## Discovery Series DSL 714 Abdominal machine pivot bolt torque update

**Applies to:** DSL 714 Abdominal Crunch

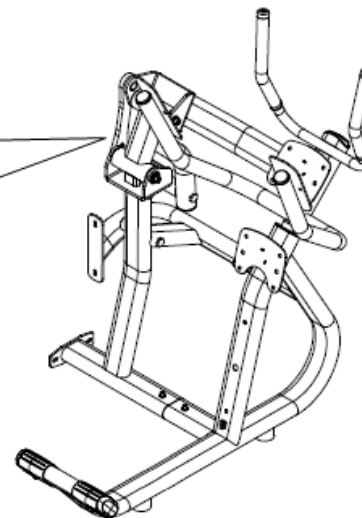
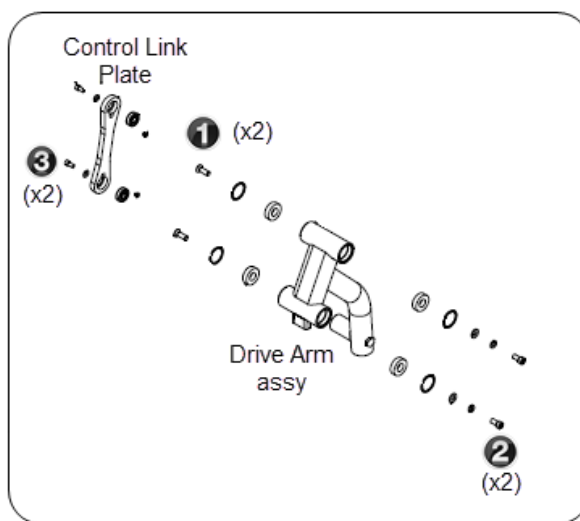
Current specified pivot bolt torque setting is not sufficient to keep bolts tight during extended use and may loosen.

Re-torque pivot bolts to new higher torque specification, from 42 ft-lbs (57 Nm) to 125 ft-lbs (169.5 Nm).

- 1 Re-torque two pivot bolts **2** (PPP000CWACN050150 1/2-13X1.5 cap head screw) to 125 ft-lbs (169.5 Nm).using a 3/8" hex bit socket.
- 2 Remove control link plate by removing two bolts **3** (PPP000CWACN038100 3/8-16 X1.00 cap screw) using a 5/16" hex bit socket.
- 3 Remove one pivot bolt **1** (PPP00CWMACCN050150 1/2-13X1.25 cap head screw) using a 5/16" hex bit socket. Apply Loctite 243 to shaft threads and re-torque to 125 ft-lbs (169.5 Nm). Repeat process for the second pivot bolt, only remove one bolt at a time.

**Important:** Only remove one pivot bolt **1** at a time. One pivot bolt holds the assembly in position while the other bolt is replaced.

- 4 Reinstall control link plate and secure with two bolts **3** (PPP000CWACN038100 3/8-16 X1.00 cap head screw) using a 5/16" hex bit socket. Torque to 42 ft-lbs (65.5 Nm).
- 5 Verify machine operation and return to service.
